APPLICATION FOR MODIFICATION ASSESSMENT REPORT

| Application Number: | Mod2024/0570 |

| Land to be developed (Address): | Lot 30 DP 25654, 57 Cutler Road CLONTARF NSW 2093 |
| Proposed Development: | Modification of Development Consent DA2022/1675 for Alterations and additions to a dwelling house |

- **Stormwater Tank and Barbeque (View Impacts)**

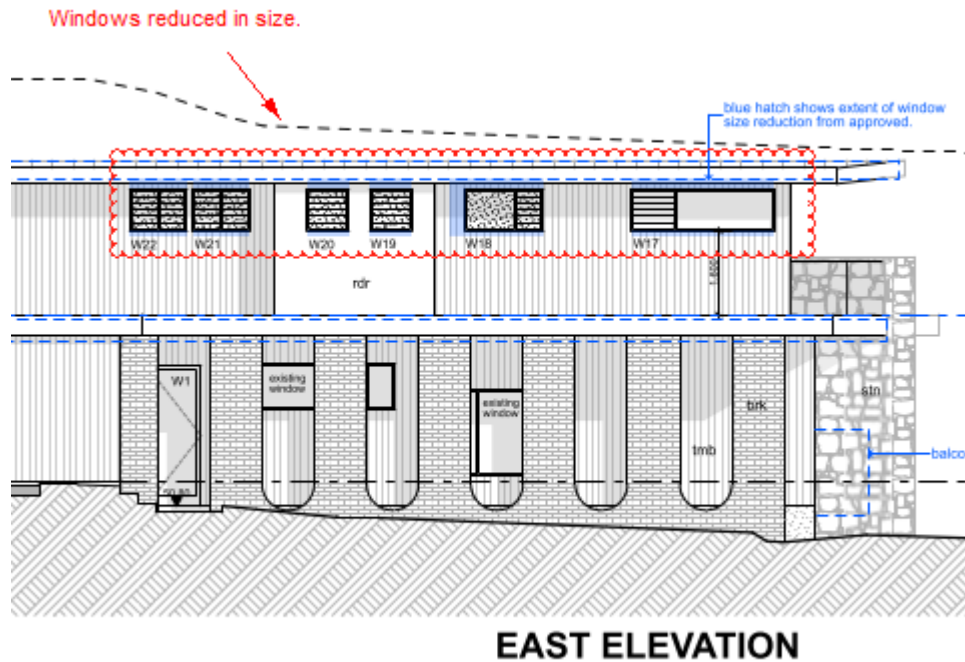
The submissions raised concerns that the proposed location of the stormwater tank and barbeque would result in a loss of views.

See section 3.4.3 of this assessment report for the detailed assessment. It is considered that the potential view loss is less than what has been approved and does not warrant an amended design or view loss assessment.

| Approved Plans | Proposed Plans |

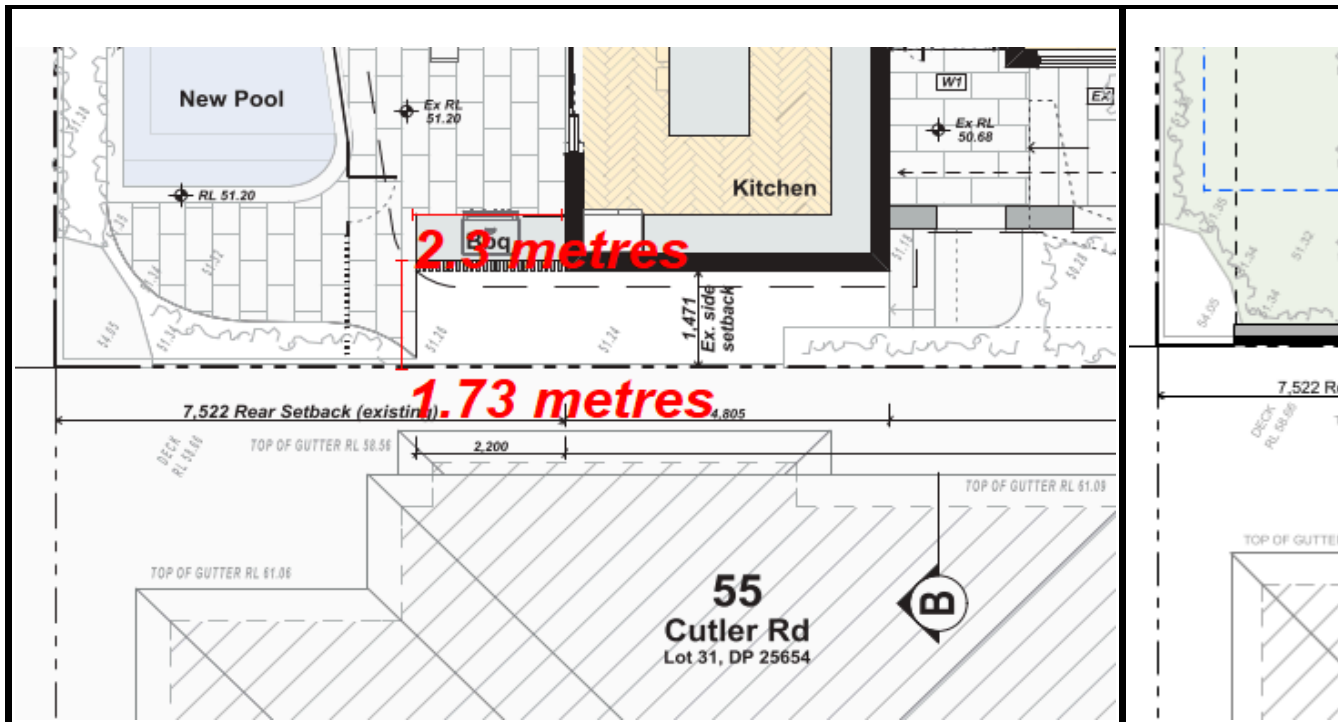
The development proposes to make alterations to the approved barbeque location and seeks the addition of a rainwater tank in its place. The altered design results in the barbeque being located further towards the west of the site by approximately 500mm. The barbeque and rainwater tank will also be reduced in length from 2.3m to 1.85m (as shown below). It is considered that the amended design will increase views obtained from No. 55 Cutler Road by reducing the depth of the barbeque, privacy screen, and rainwater tank. No further action is required by Council.
